LEXINGTON-FAYETTE URBAN COUNTY GOVERNMENT CONTRACT CHANGE ORDER Page 1 of 2		Date:	July 18, 2016
		Project:	Fire Station #2 Replacement
		Location:	Lexington
To (Contractor): Olympic Construction, LLC 216 Bromme Drive Nicholasville, KY 40356	Contract No.	013-2016	
	Original Contract Amt.	\$4,618,900.00	
	Cumulative Amount of Previous Change Orders	\$725.65	
	Percent Change - Previous Change Orders	0.02%	
	Total Contract Amount Prior to this Change Order	\$4,619,625.65	
	Change Order No.	3	
You are hereby requested to comply with the following changes from the contract plans and specification;			
Current Change Order

CHANGE ORDER NO. 3

Work Changes Proposal Request No. 4

Project: 13117 Lexington Replacement Fire Station No. 2
City Job No. 161-2015/038-2016

Partial Plan - First Floor Lighting

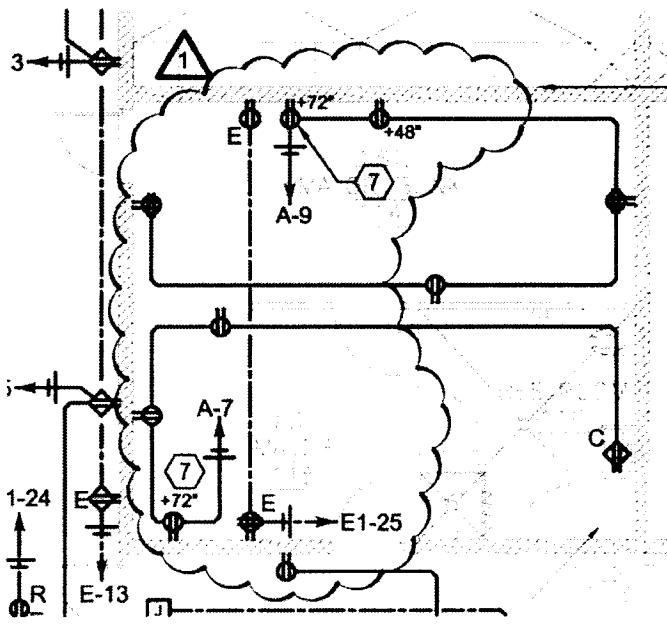
ADD SWITCHES AT RESTROOM ENTRY DOORS TO PROVIDE MANUAL ON/VACANCY OFF OPERATION; CONNECT ONE FIXTURE FOR NIGHT LIGHT OPERATION AS NOTED

Partial Plan - First Floor - Power

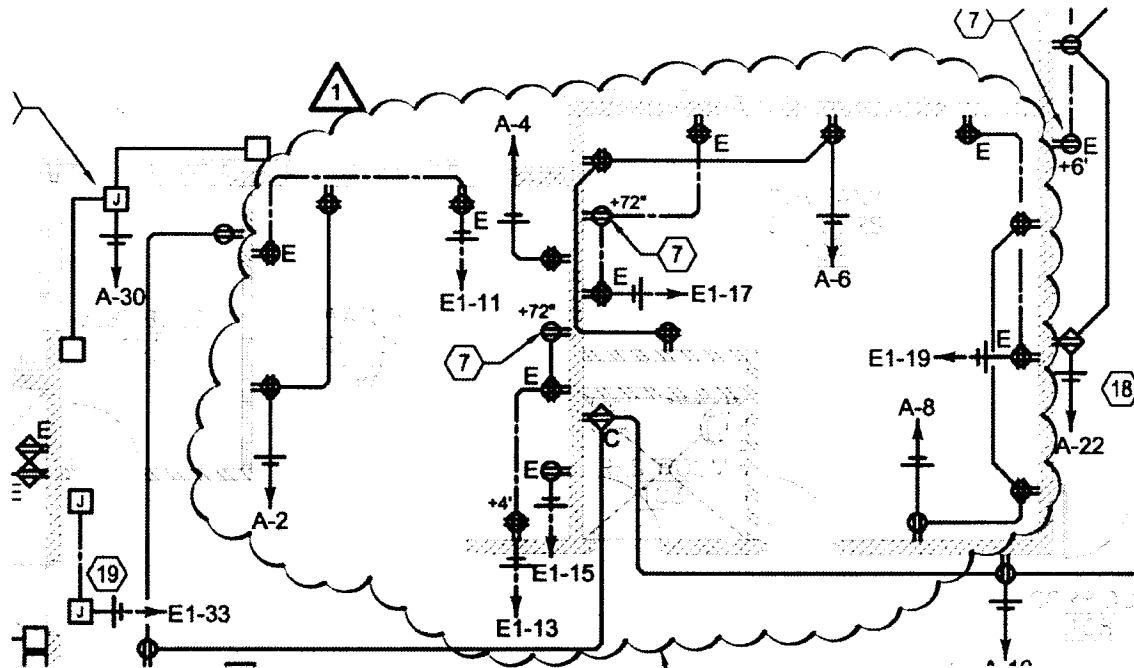
DELETE RELAYS AND ASSOCIATED CONTROL WIRING FOR RECEPTACLE CONTROL, RELOCATE/ADD RECEPTACLES FOR TV FOR WALL MOUNTING BRACKETS

Partial Plan - First Floor - Systems

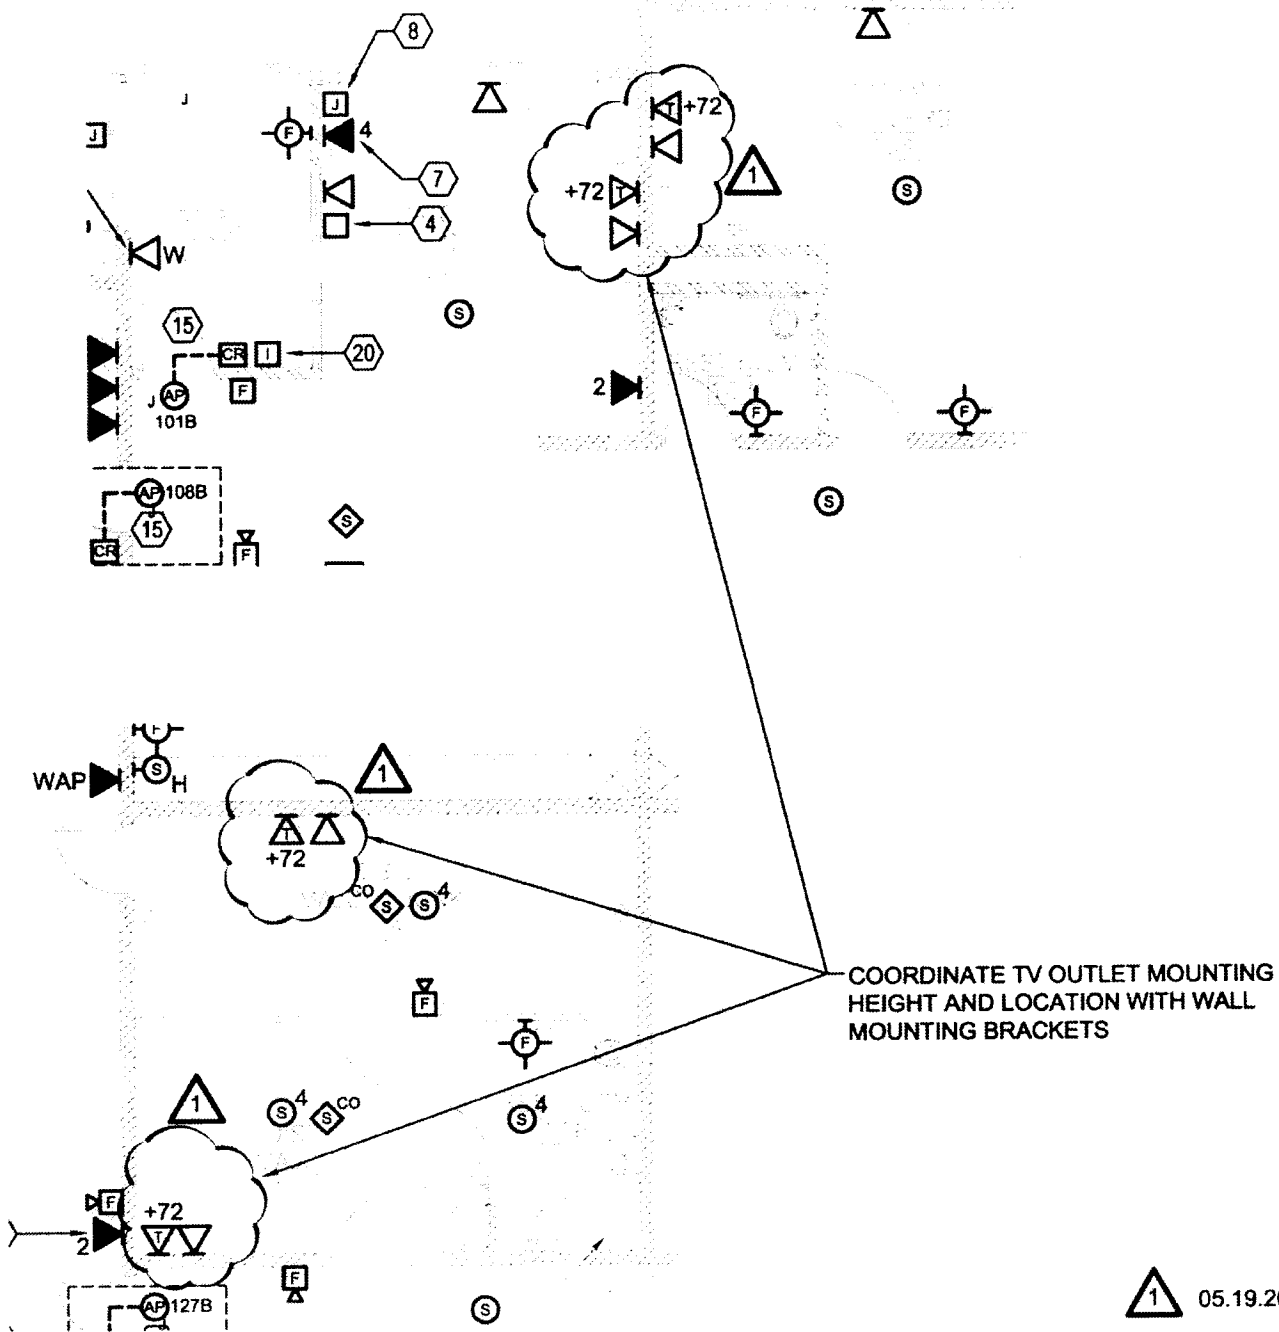
- c) Revise power and communication outlet locations for wall mounted TVs
in Rooms 102, 104, 114, and 115
